County of Fairfax, Virginia

MEMORANDUM

SUBJECT: Preliminary Land Use Comments:
Plan Amendment (PA) 2023-II-2F – Pohick Estates

Trails Plan Map:

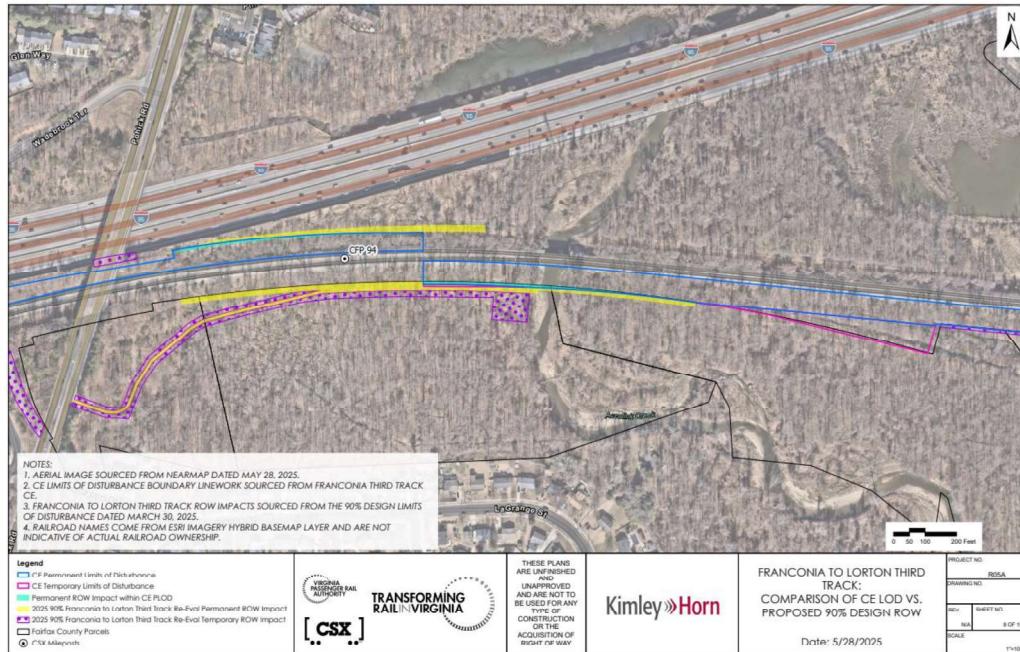
- Pohick Road is planned to have a major paved trail along the eastern side. This facility is not shown on the concept but would be expected with development to connect the site to Lorton Station Boulevard, enabling future residents to walk to area amenities. DOT may have additional comments on this facility, expected buffer width, and road crossings following formal amendment review.
